HRE major work review template

Proforma for SAF consideration

Structure name	Asset ID	NH Priority Rank
Braughing Station Bridge, Hertfordshire	SMB/2062	P1

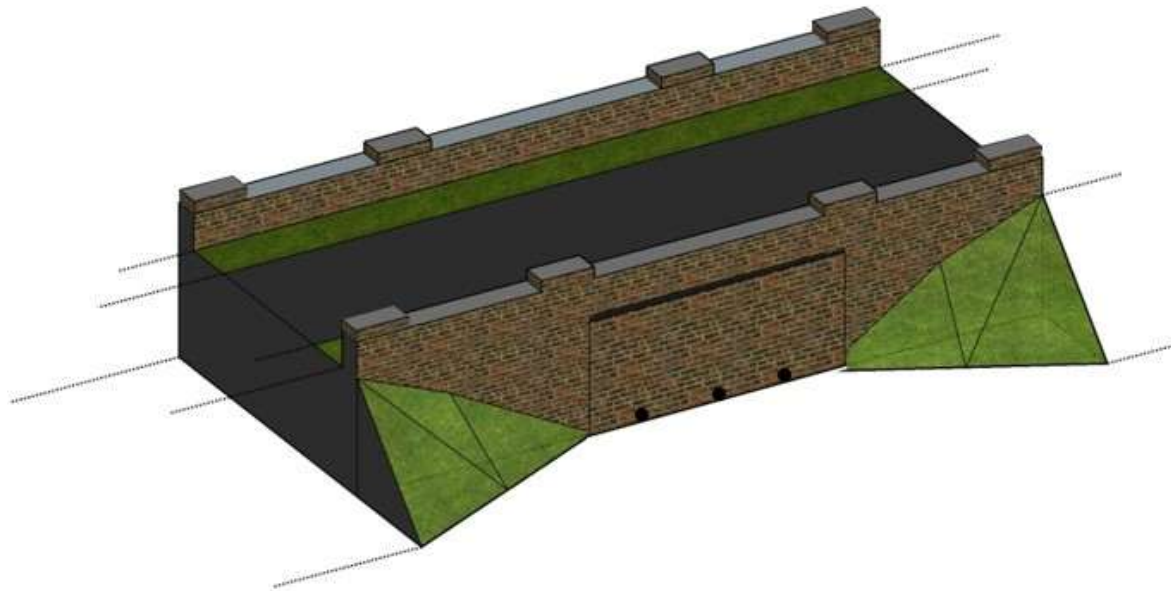
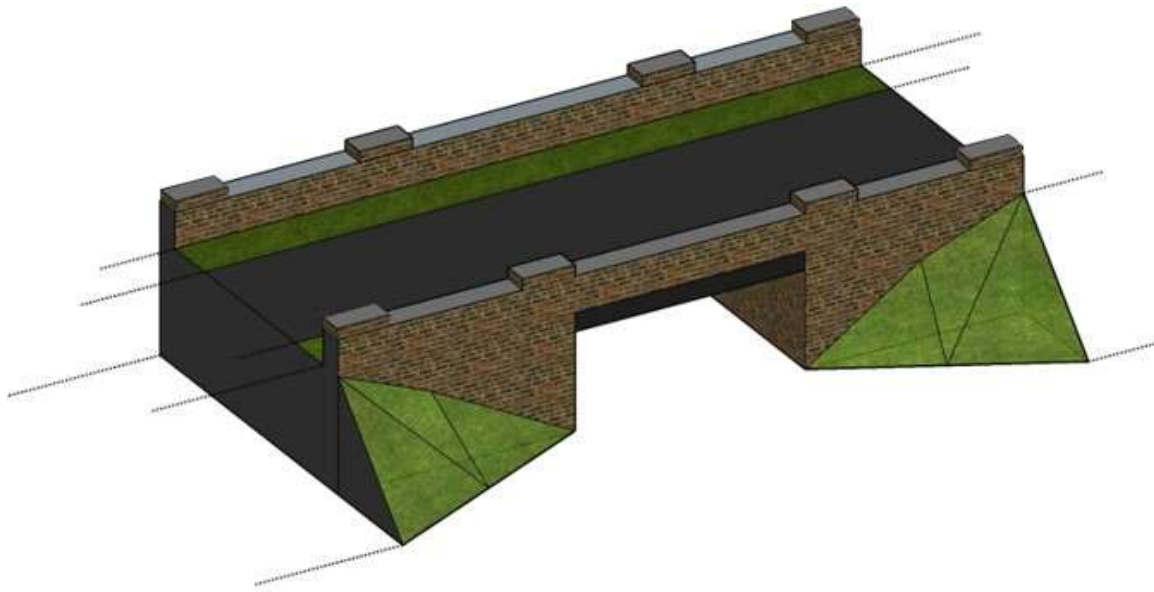
Southern edge beam severe corrosion.

Southern edge girder, eastern end support.

Southern internal beam soffit.

Fractures in abutment below padstone.
